PHILADELPHIA ELECTRIC COMPANY

Subject: Limerick Generating Station, Units 1&2
Information for Auxiliary Systems Branch
(ASB)

LIST OF OPEN SER ISSUES - AUXILIARY SYSTEMS BRANCH

LGS FIG Q 410.16-3

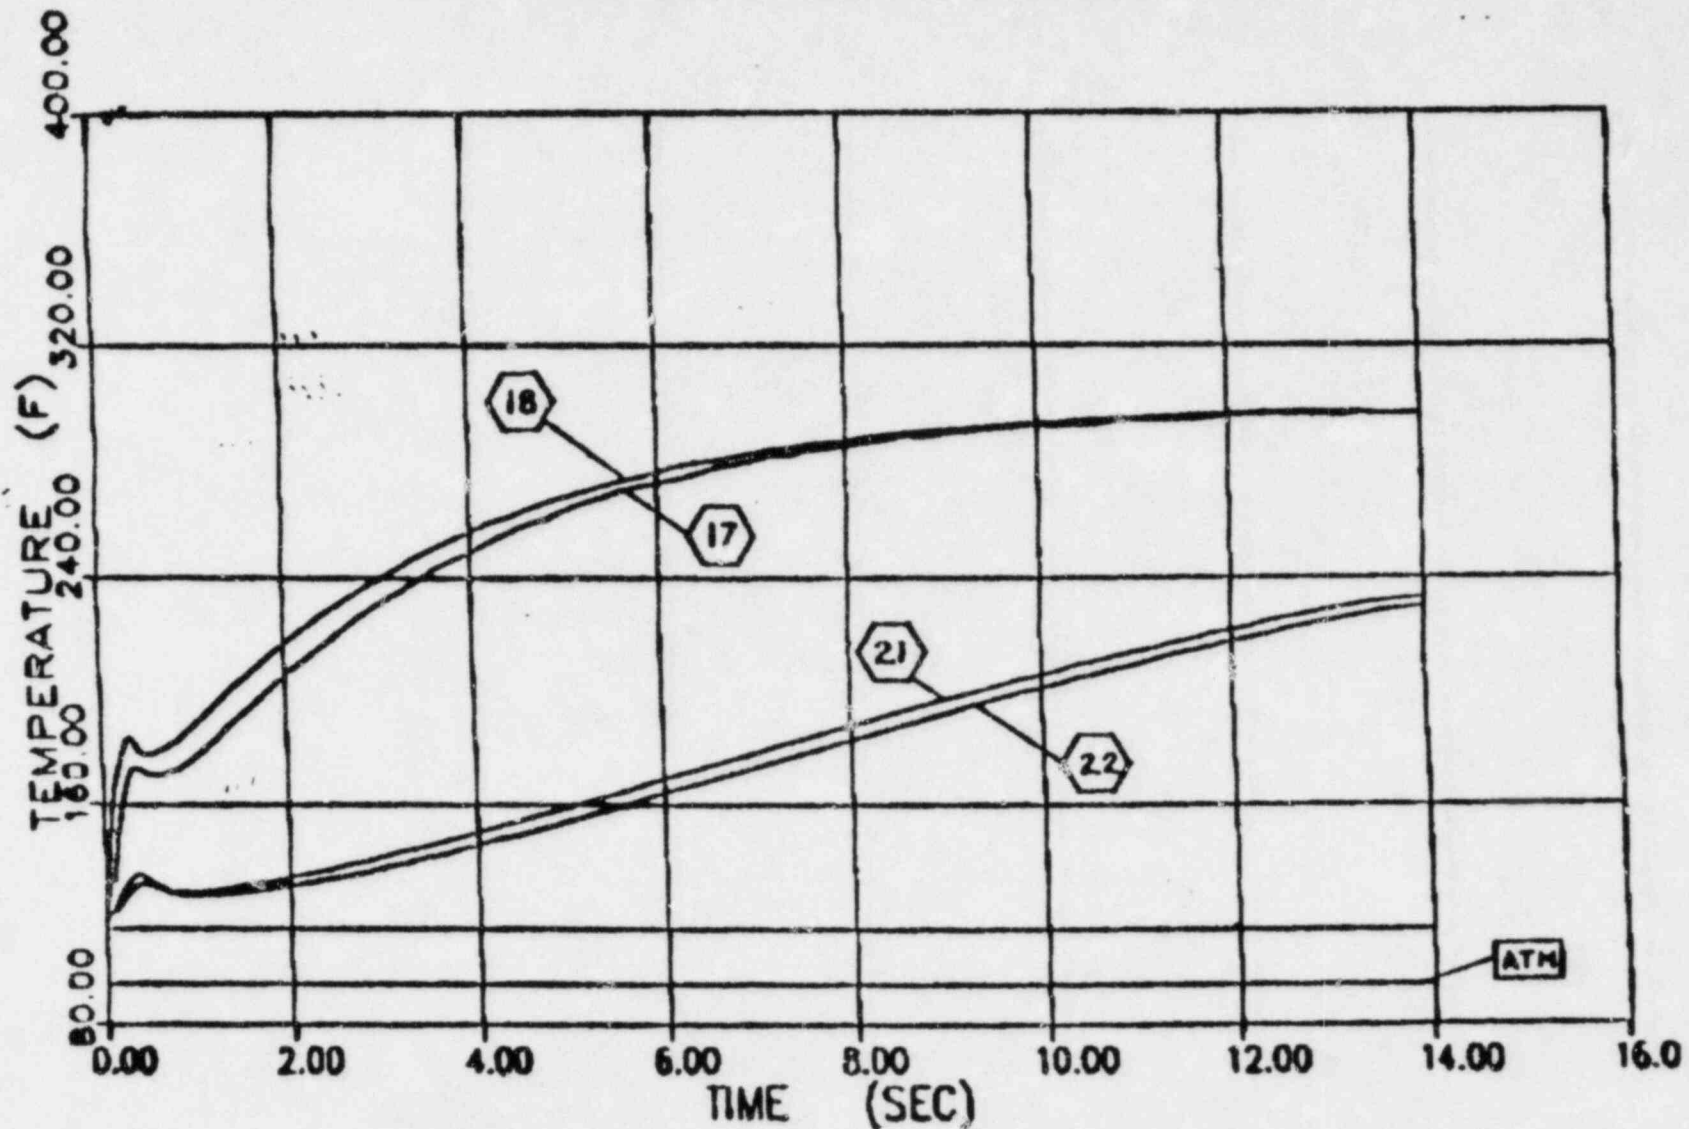
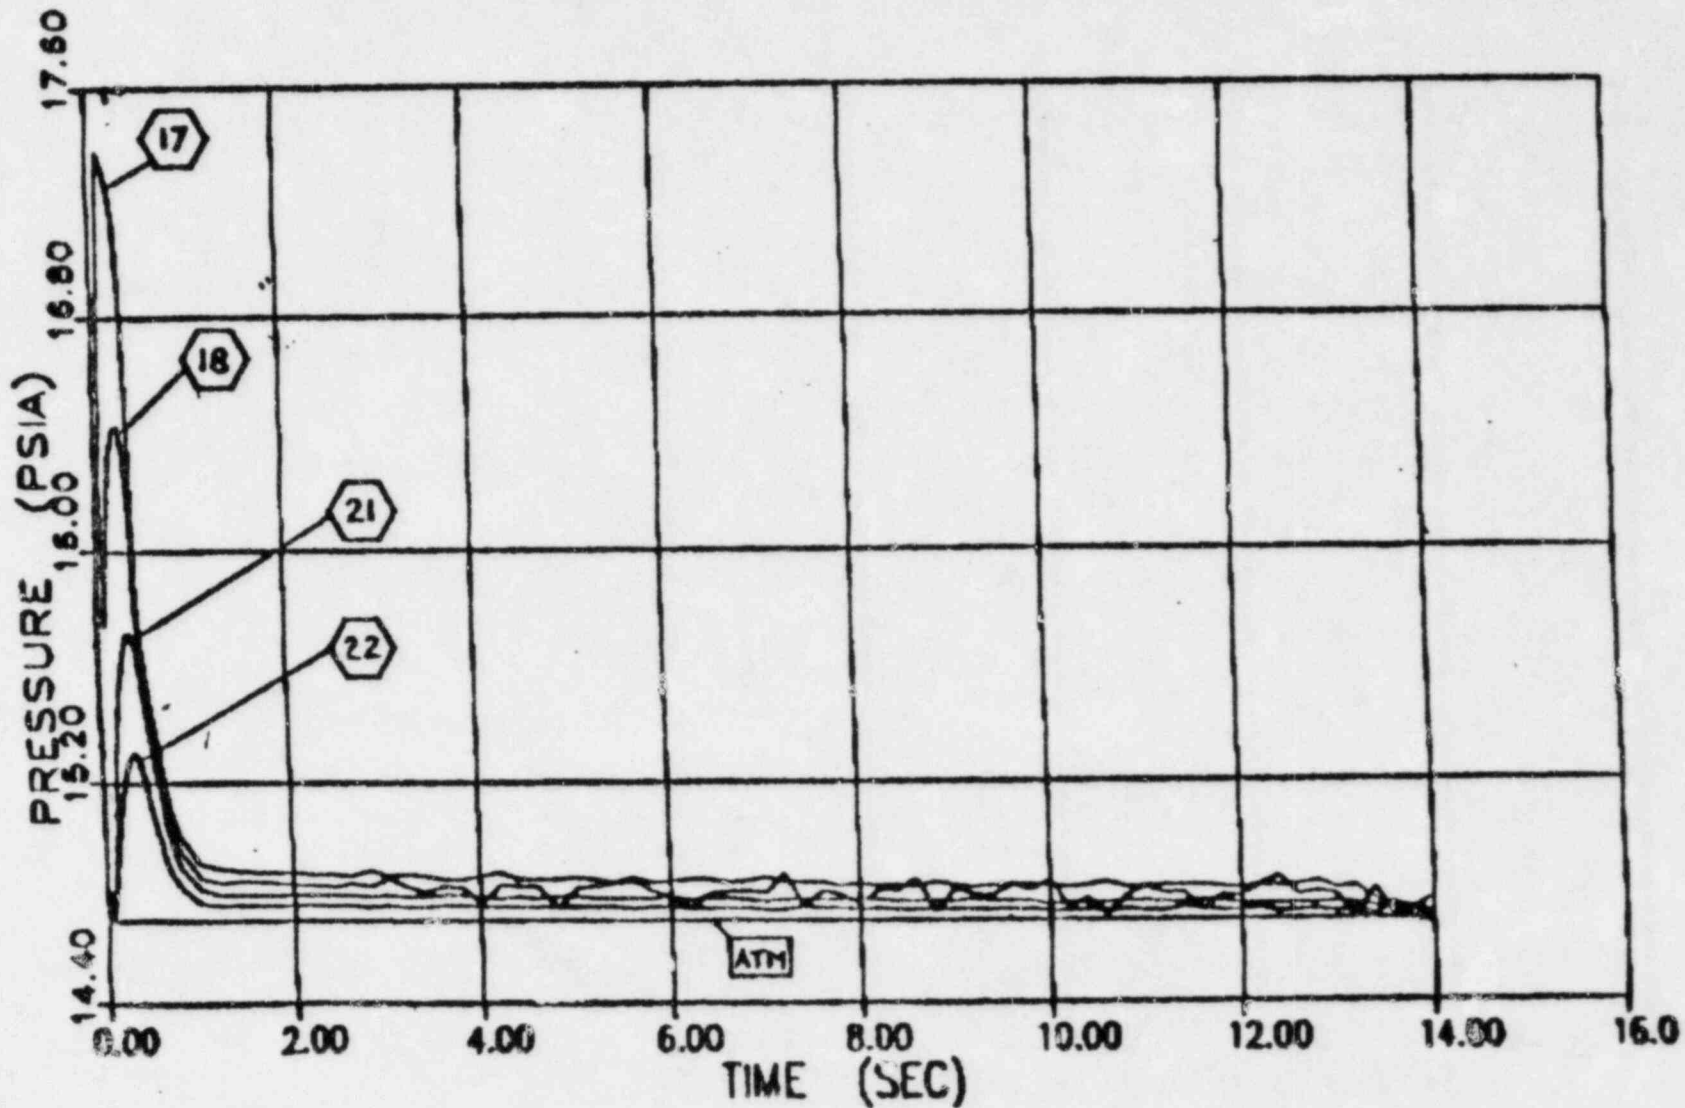
Provide drawings of typical high energy piping which shows all anchors, jet impingement barriers, postulated break locations, wall penetrations, and references to general arrangement drawings which show the location of each section of piping. Provide isometric drawings if they are available. Provide the missing FSAR tables referenced in Section 3.6.1 of the FSAR.

→ so that a detailed review of a typical pipe break analysis can be performed, in accordance with SRP 3.6.1 and Branch Technical Position ASB 3-1. The pipe break chosen, is a break of the HPCI steam supply line in the HPCI compartment.

1. Environmental conditions and compartment dimensions (FIGURE Q410.16-1).
2. Temperature profile of the HPCI compartment following the break. (FIG. Q410.16-2)
3. Pressure profile of the HPCI compartment following the break. (FIG. Q410.16-3).
